PCN Number:	20131024000	PCN Date:	10/28/2013
Title:	Carrier Tape Change for Select products in 6L DSBGA package		
Customer Contact:	PCN Manager	Phone:	+1(214) 480-6037
Dept:	Quality Services		
Proposed 1st Ship Date:	10/28/2013	Estimated Sample Availability:	10/28/2013
Change Type:	<input checked="" type="checkbox"/> Packing/Shipping/Labeling

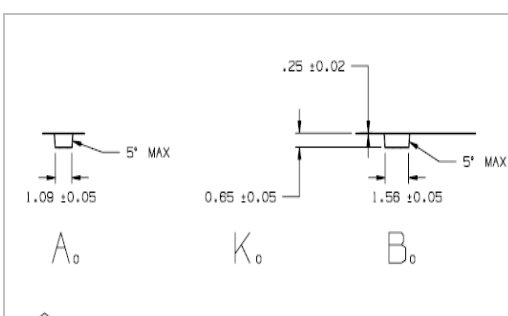
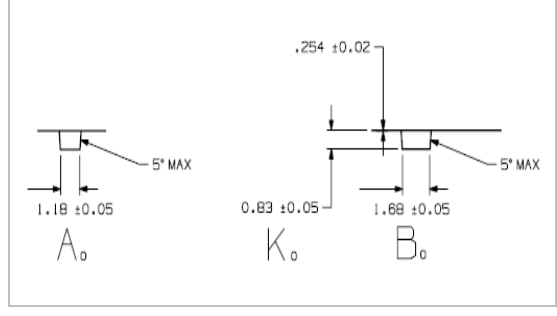
A new deep pocket designed carrier tape will be used for the listed devices below. Comparison between new and old carrier tape is as follows:

From	To
Stock #	4156725-0193	4156725-0181
Ao (mm)	1.09	1.18
Bo (mm)	1.56	1.68
Ko (mmm)	0.65	0.83
Drawing

Quality improvement to address "sticky die"
